Town of Parker Community Development Department
 Development Review Division
 Attention: **Stacey Nerger**

Application Type: **Site Plan**
 Status: **First Referral**
 Application Name: Lincoln Professional Park L3 - Andy's Custard
 Case/AP#: **SP22-113**
 Referral Received: October 5, 2022
 Comments Due: November 2, 2022

Application Location: Generally located on the south side of Lincoln Avenue between Dransfeldt Road and Parker Road
 Review date: **October 21, 2022**
 Plan reviewer: **Randall L. Capra, rcapra@parkeronline.org**
 Phone: 303.805.3163

Narrative: The applicant, Galloway, is proposing a 1,947 sq. ft. frozen custard drive through. The site is located on the south side of Lincoln Avenue between Dransfeldt Road and Parker Road.

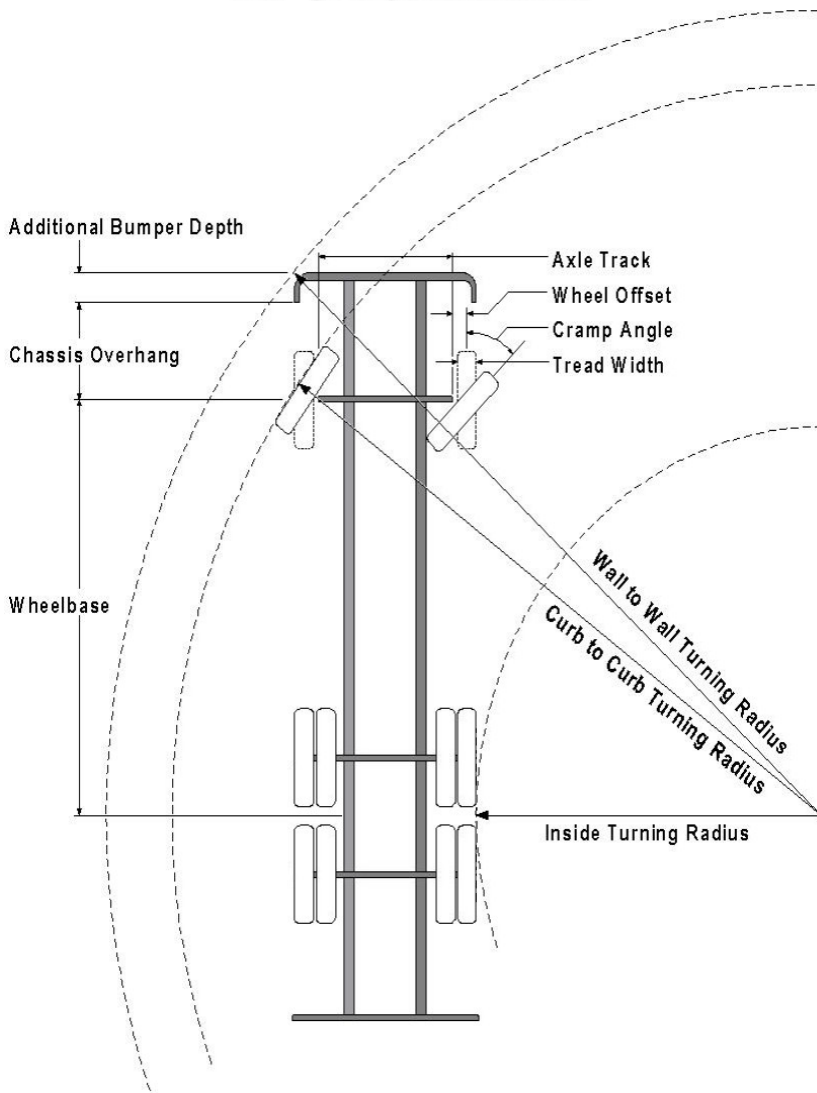
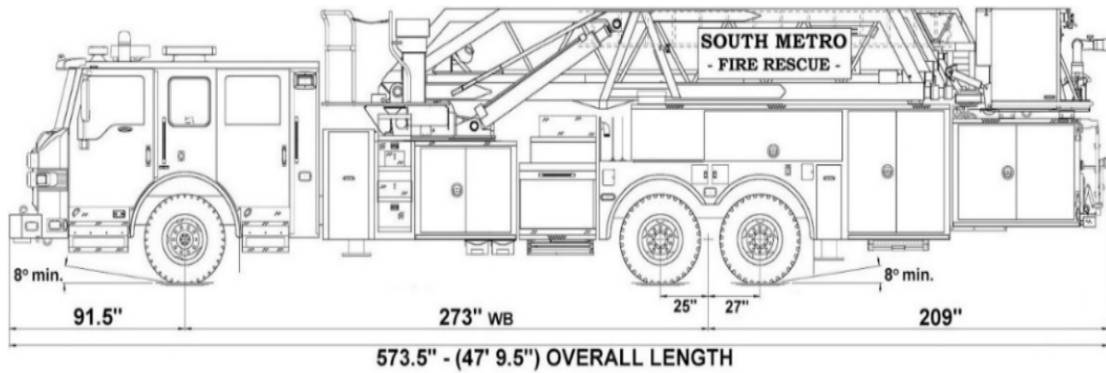
1. The applicant shall be aware that **no vertical construction on this site will be allowed until such time that curb gutter and first lift of asphalt are installed**; a site inspection will be required to ensure that this requirement is made prior to allowing vertical construction to commence. *Satisfied; applicant has acknowledged with second submittal.*
2. The applicant shall provide NO PARKING – FIRE LANE signage for any portion of the access where the 24-foot clear width requirement cannot be met; areas that are required to have this signage are located on both the north and sides of the building. *Not satisfied; the applicant will be required to provide two NO PARKING – FIRE LANE signs in the area shown below. Address this issue when resubmitting.*

7. While the applicant has provided an auto-turn analysis, in addition to what was provided, two additional routes shall be provided when resubmitting; see the redlined drawing below for the required locations... apparatus shall be able navigate all portions of this site... and address this issue when resubmitting: **Partially satisfied; applicant has provided the required auto turn analysis. The analysis indicates a clear movement though this movement can be obstructed by vehicles in the drive through access. As such, signage shall be provided at the intersection on the south end "DO NOT OBSTRUCT ACCESS". Satisfied; applicant has addressed with second submittal.**
